**WOKINGHAM
BOROUGH COUNCIL**

Outline Planning Approval Consultation

Application Number: 243099

Site Address: Land North Of Reading Road, Arborfield

Visibility Splays

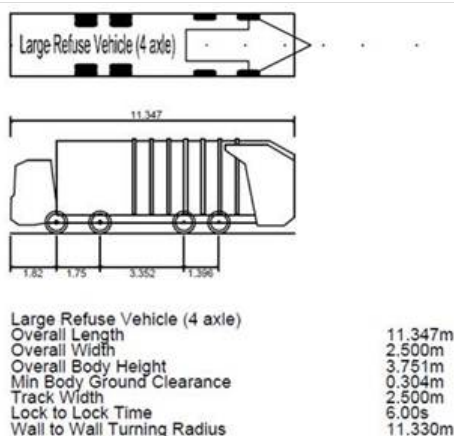
60. Visibility splays for the proposed new access have been submitted with reference to the 85th percentile speed of Reading Road. The calculations of the visibility splays would need to be submitted. **These calculations are still required to be submitted.**
61. The visibility splay to the west appears that it maybe obstructed by the tree as shown below.

62. Evidence would need to be submitted that this is not the case. **A statement has been made that the visibility splay is not impacted by the tree, though no evidence has been provided. The size of the tree trunk shown on the plan does not represent what is on the ground.**
63. Any landscaping within the splays would need to be maintained so that it is less than 0.6m high. **This has been agreed which is welcome.**
64. Pedestrian and cycling visibility splays need to be provided for the proposed access onto Reading Road. **These are still required.**

Swept Paths

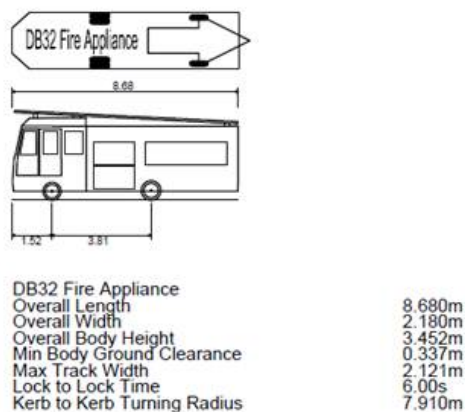
65. All movement swept paths of a refuse vehicle have been provided which is welcome. However, the dimensions are not acceptable. The dimensions that would need to be used are as follows: -

These have been provided. However, there are no swept paths for the refuse vehicle turning out. These need to be submitted. The swept paths of the refuse vehicle entering the site clearly shows that when the vehicle enters the access no vehicle can be waiting to exit. In addition, from both directions, the overhang of the vehicle is at the end of the pavement.

66. Highways would need to see swept paths of the refuse lorry entering the site from both directions whilst a car is waiting to exit. **These have not been submitted and are required. However, based on the comments above I doubt they would work**
67. Highways would need to see the swept paths for a refuse vehicle and a large car passing each other on the site roads. **These have not been submitted and are required.**
68. Highways would also need to see the swept paths for the fire tender accessing and egressing the main access. **These have been submitted which are acceptable.**
69. Please note that the dimensions of the fire tender approved by the Borough are as follows:
